Memorandum

SUBJECT: LUC-2018-219, 261 Tomahawk Road, Ocean Grove. Comment from Landscape Architect

Figure 5: View from northwest of the site (near 60 Puketai Street)

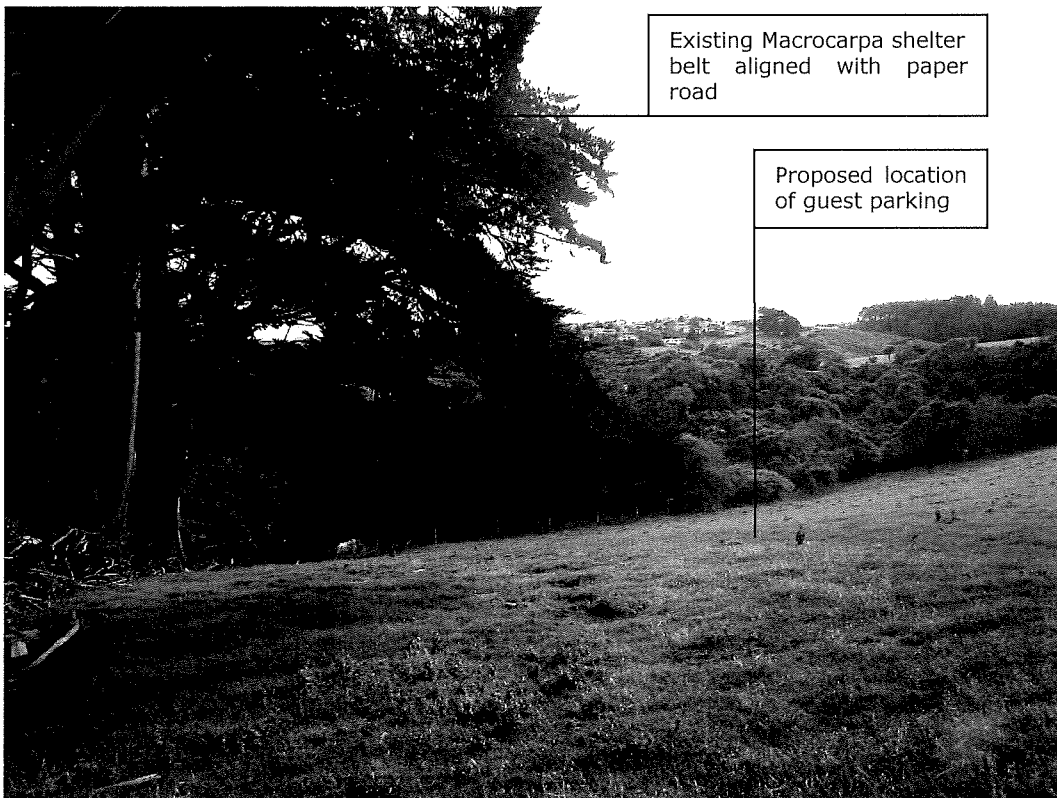
Views towards the site are available from a range of surrounding locations, including the western extent of Ocean Grove, and the eastern extent of the hill suburbs of Andersons Bay and Shiel Hill. As seen in figures 5 & 6, views of the proposed guest parking area are likely to be at least partially visible from these locations. To avoid adverse effects associated with this feature of the development contrasting with existing pastoral views it is recommended that some additional shelterbelt planting is undertaken along the western boundary of the parking area (refer Appendix 2).

- Additional Macrocarpa shelterbelt planting shall take place along the western boundary of the proposed carpark to the corner of the paddock, as shown in the marked-up plan attached as Appendix 2. This planting shall take place in the first planting season following granting of consent.
